SUBJECT: Illinois Valley Regional Airport
Peru, Illinois
LaSalle County
Illinois Project Number: VYS-4516
SBG Project Number: 3-17-SBGP-144/156/162/171
Contract No. IL033
Item No. 09A, January 21, 2022 Letting
Addendum B

NOTICE TO PROSPECTIVE BIDDERS

Addition of Pay Item AR401900 Remove Bituminous Pavement, Special Provision revisions, and Addition to the plans issued as Addendum B.

REMOVAL PLAN

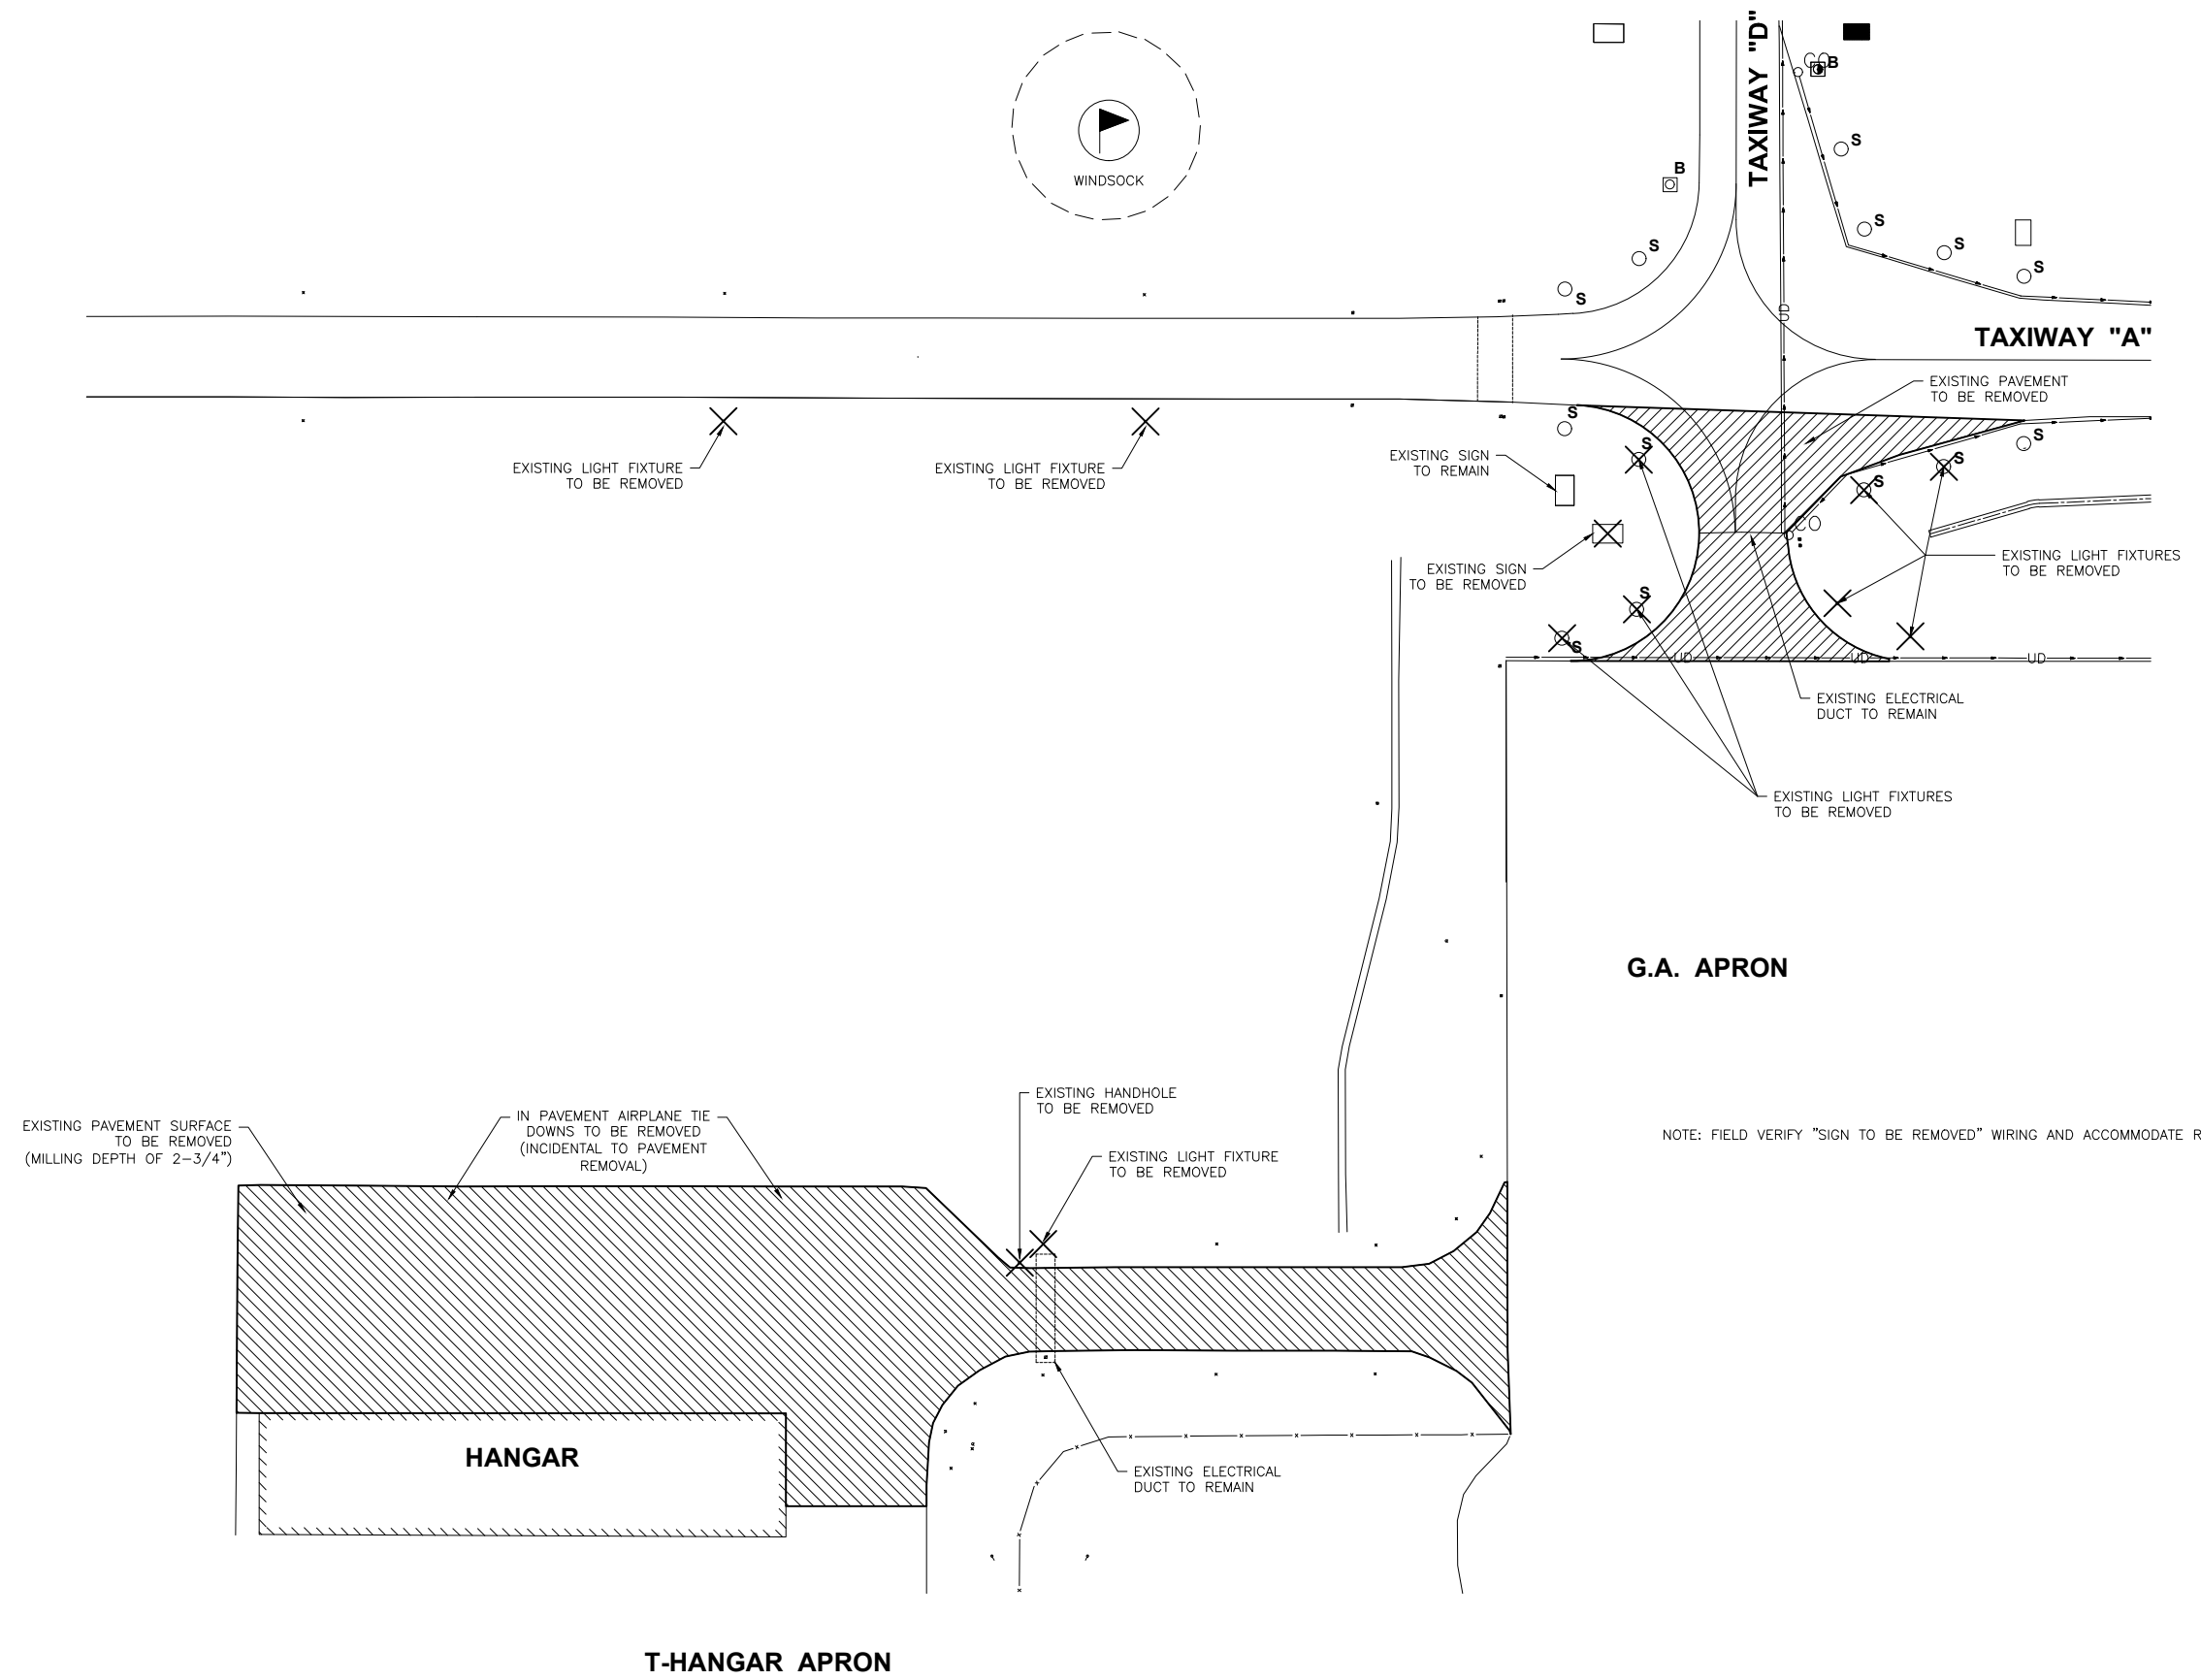
ITEM AR 401900 REMOVE BITUMINOUS PAVMENT

- b. Asphalt Pavement Removal.** Asphalt pavement to be removed shall be cut to the full depth of the asphalt pavement around the perimeter of the area to be removed as specified in the contract documents at locations determined by the Resident Engineer. After completion of the saw cutting, the Contractor shall remove the pavement structure, including

aggregate subgrade, using methods which will allow a vertical surface along all sides of the removal area. Material obtained from the removal operations shall be hauled to a disposal site off of airport property by the Contractor. If the material is to be wasted on the airport site or incorporated into embankment, it shall be broken to a maximum size designated by the Resident Engineer. The pavement shall be assumed to be ten (10) inches of Asphalt pavement and eight (8) of aggregate base course.
